NRC DOCKET 50-366  
OPERATING LICENSE NPF-5  
EDWIN I. HATCH NUCLEAR PLANT UNIT 2  
REQUEST TO CHANGE TECHNICAL SPECIFICATIONS  
FOURTH CORE RELOAD

PROPOSED TECHNICAL SPECIFICATIONS REVISIONS

FIG 3.2.1-1

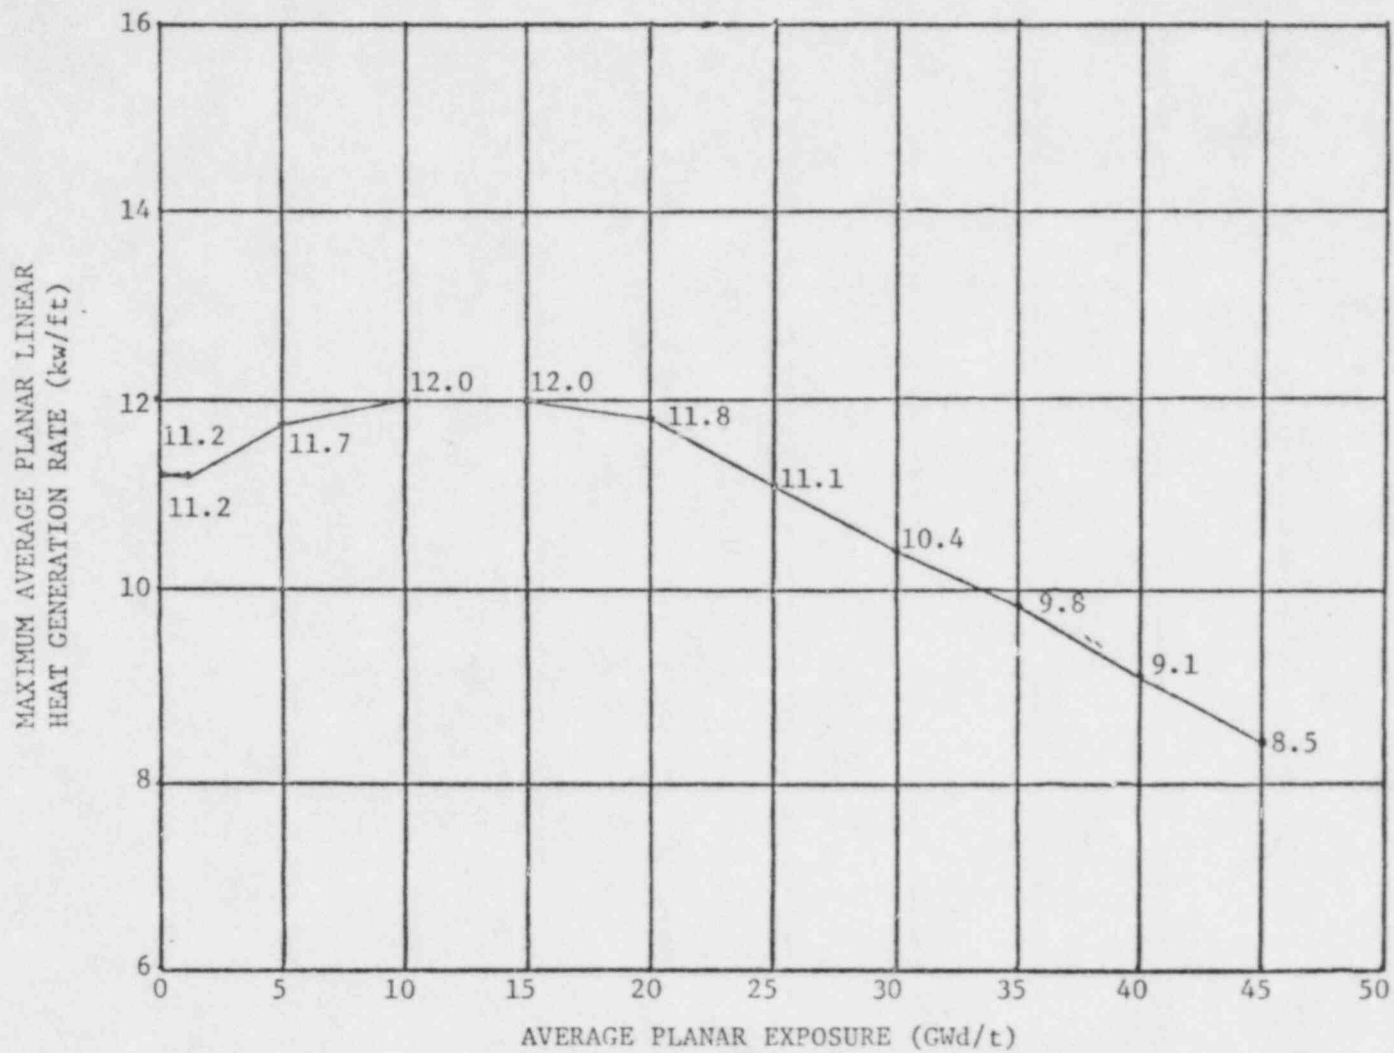
FUEL TYPE 8DIB175(8DRL183)  
MAXIMUM AVERAGE PLANAR LINEAR HEAT GENERATION  
RATE (MAPLHGR) VERSUS AVERAGE PLANAR EXPOSURE

FIGURE 3.2.1-9

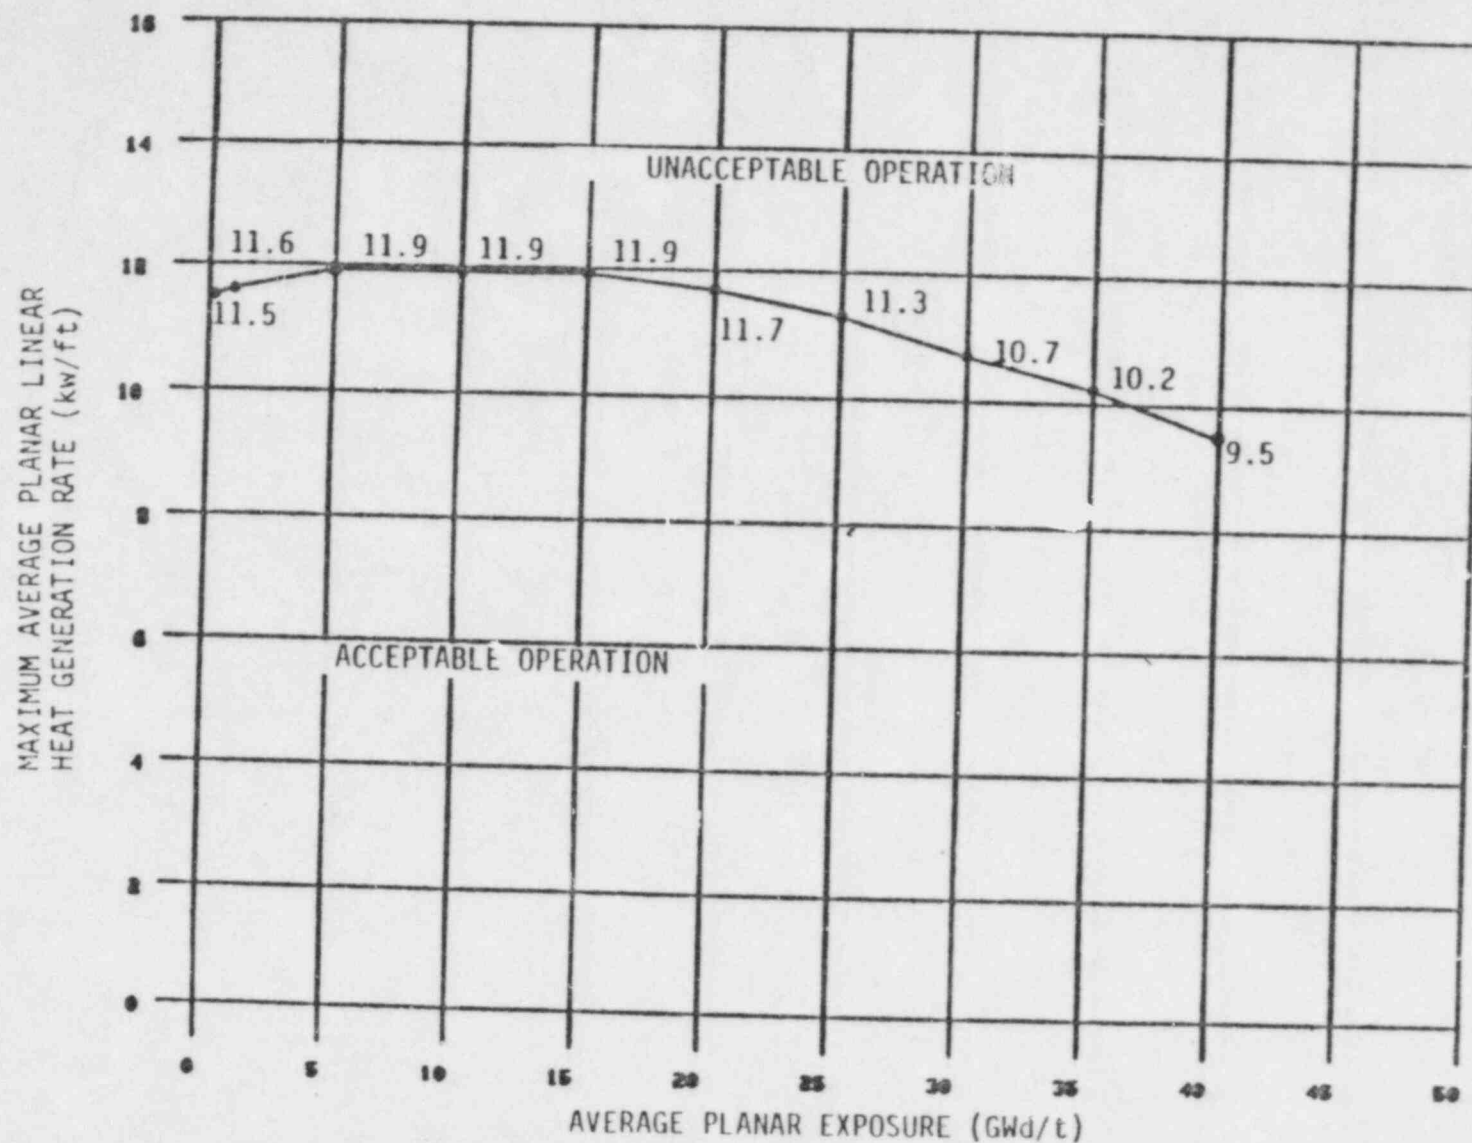
FUEL TYPE P8DRB284H  
MAXIMUM AVERAGE PLANAR LINEAR HEAT GENERATION  
RATE (MAPLHGR) VERSUS AVERAGE PLANAR EXPOSURE
